December 21, 2016  
NND-16-0554  
10 CFR 50.90  
10 CFR 52.63

Virgil C. Summer Nuclear Station (VCSNS) Units 2 and 3  
Docket Numbers 52-027 and 52-028  
Combined License Numbers NPF-93 and NPF-94

**Subject:** Request for License Amendment and Exemption: Ventilation System Changes (LAR 13-30)

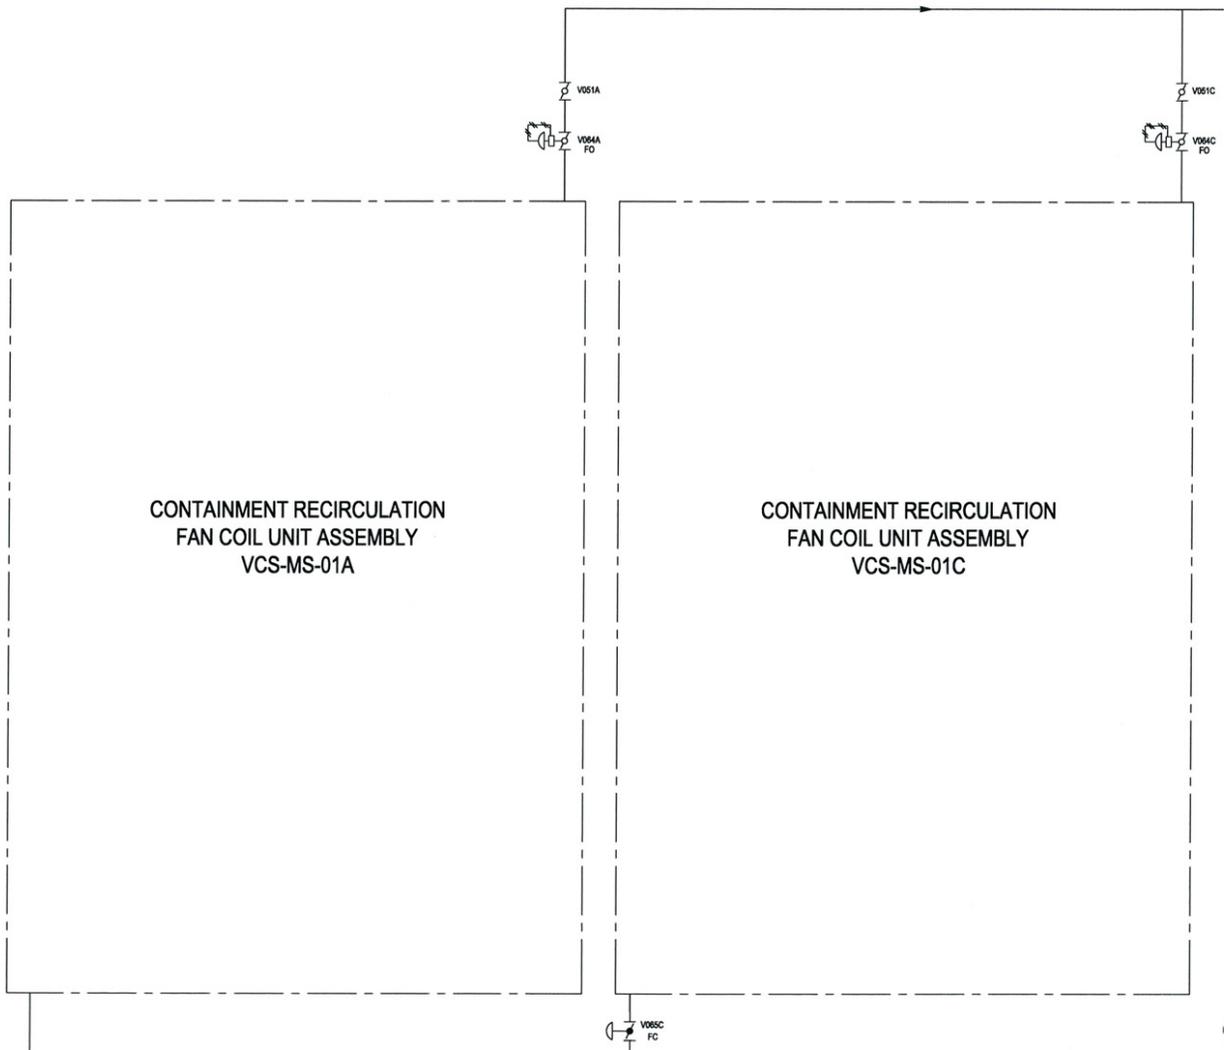
**Revise Tier 1 information, as shown below:**

**3. UFSAR Section 9.2, "Water Systems," Figure 9.2.7-1 (Sheet 3 of 4), "Simplified Central Chilled Water System Piping and Instrumentation Diagram (REF) VWS 003":**

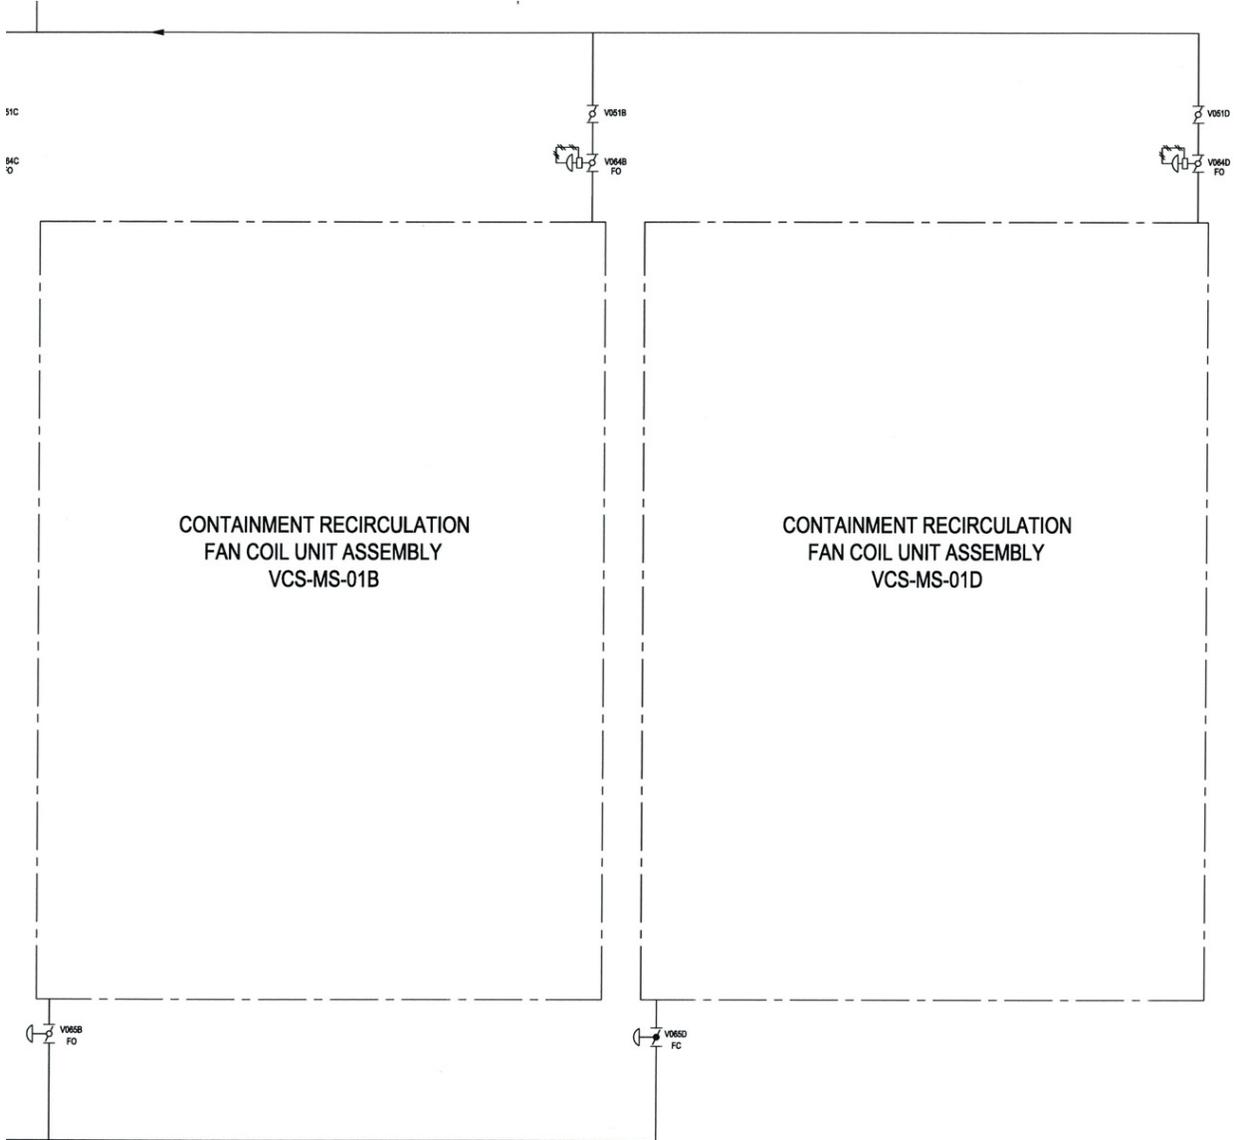
**Revise Tier 2 information to add new containment recirculation fan coil unit assembly, VCS-MS-01C, to the units served by the central chilled water system (VWS) and alternately by the hot water heating system (VYS), as depicted below in the excerpt from the left side of the figure:**

**Revise Tier 2 information to add new containment recirculation fan coil unit assembly, VCS-MS-01D, to the units served by the VWS and alternately VYS, as depicted below in the excerpt from the right side of the figure:**

8. **UFSAR Section 9.4, Figure 9.4.6-1, "Simplified Containment Recirculation Cooling System Piping and Instrumentation Diagram (REF) VCS 001"**:

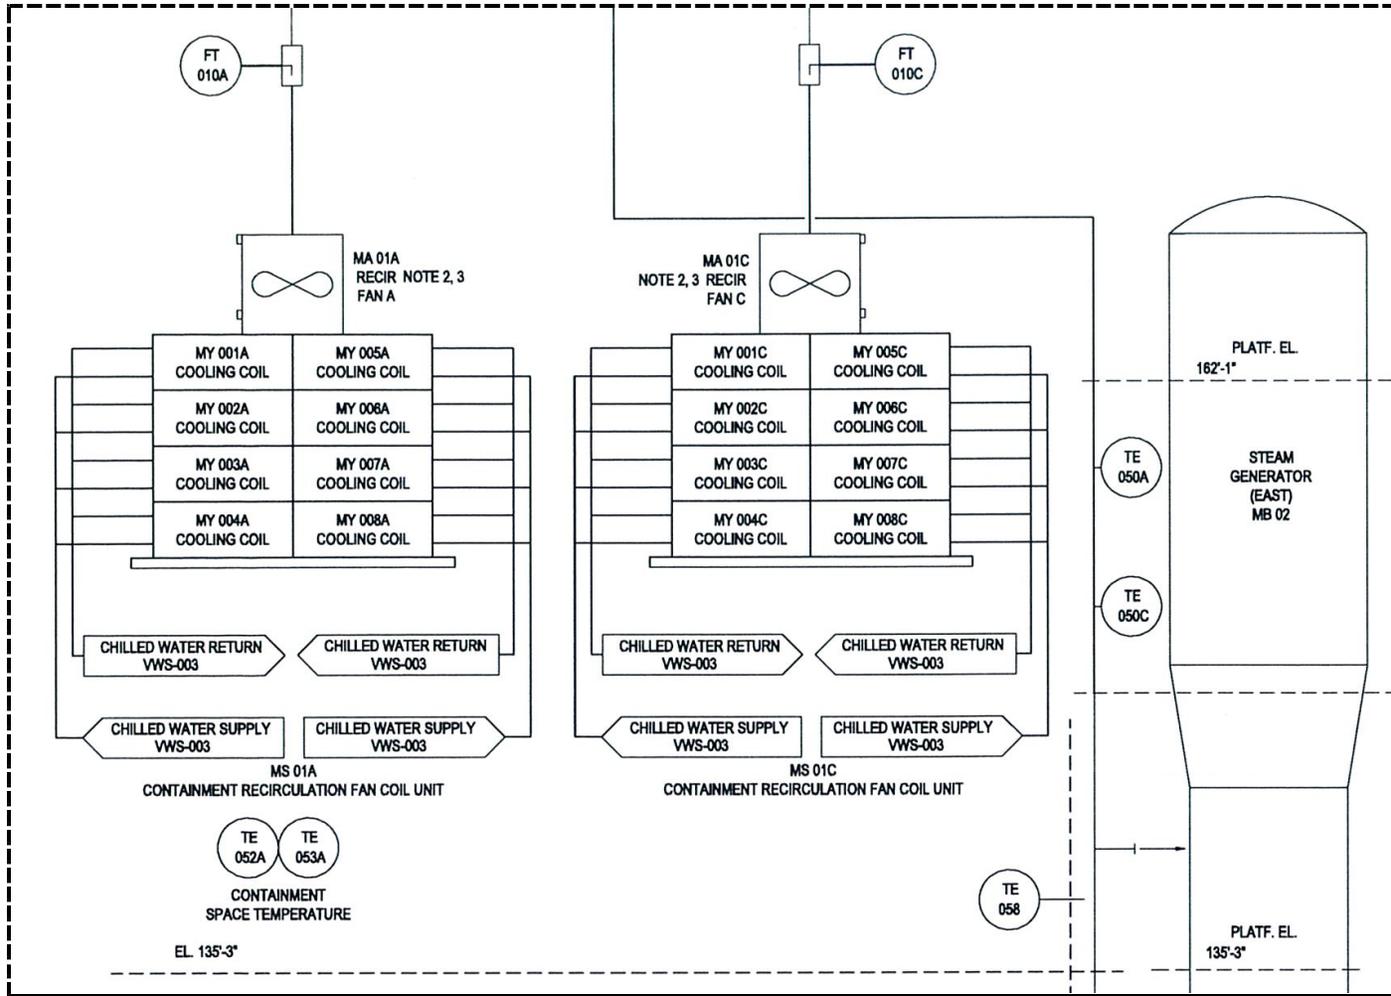
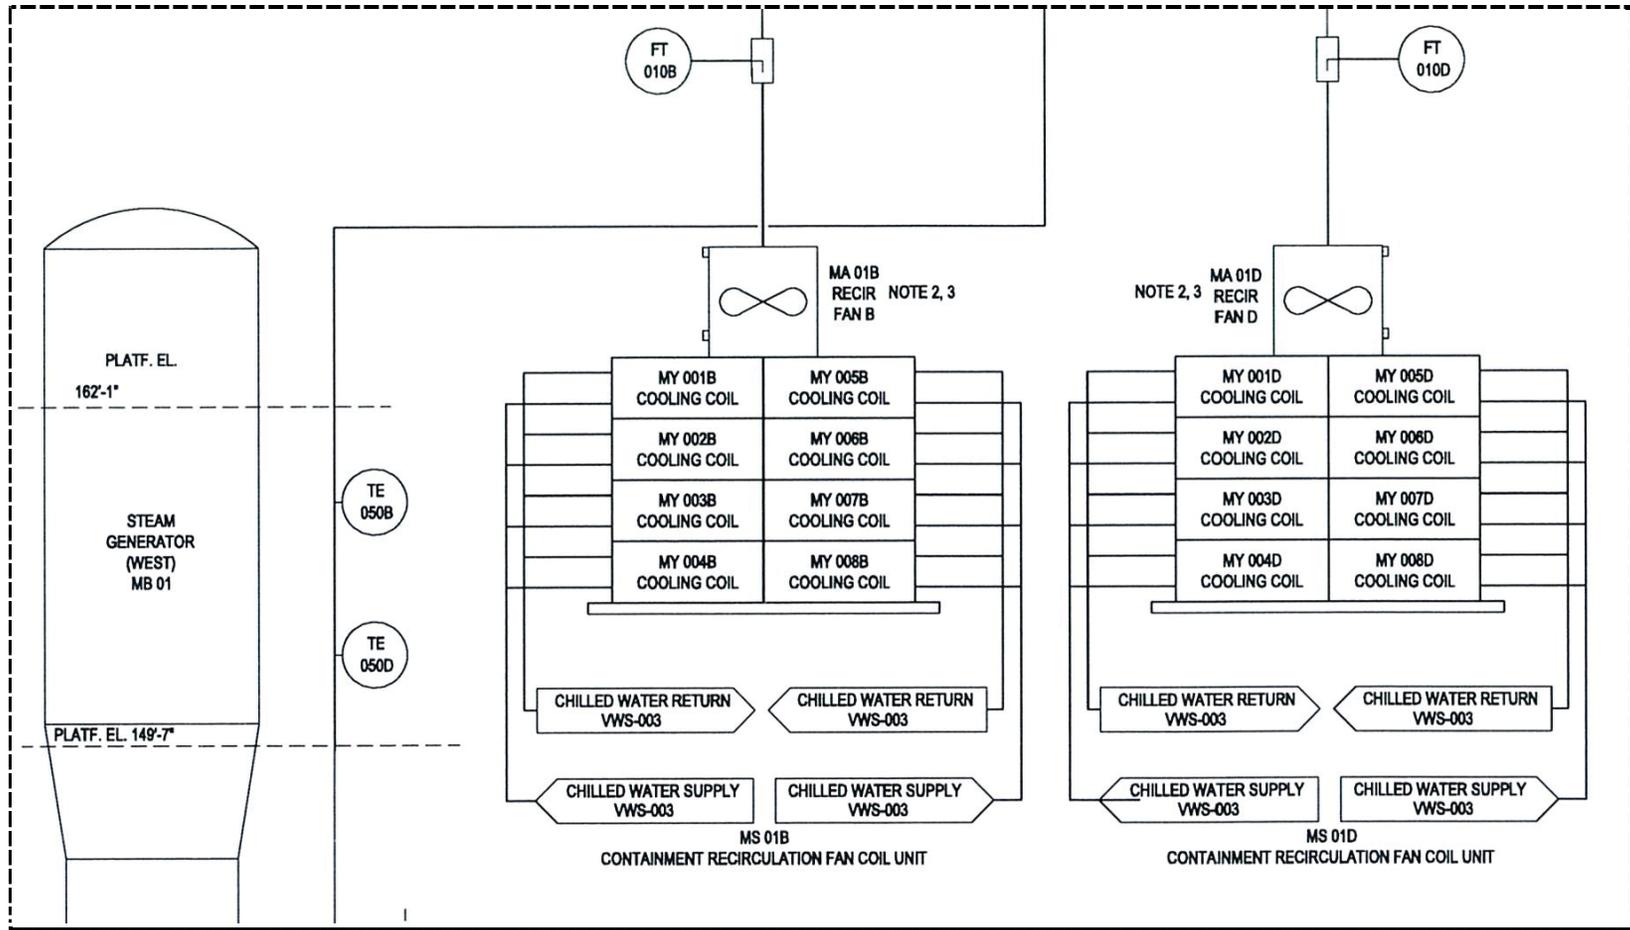
Revise Tier 2 information to change the number and configuration of the containment recirculation fan coil unit assemblies, as depicted below in the excerpt from the left side of the figure:

Revise Tier 2 information to change the number and configuration of the containment recirculation fan coil unit assemblies, as depicted below in the excerpt from the right side of the figure:
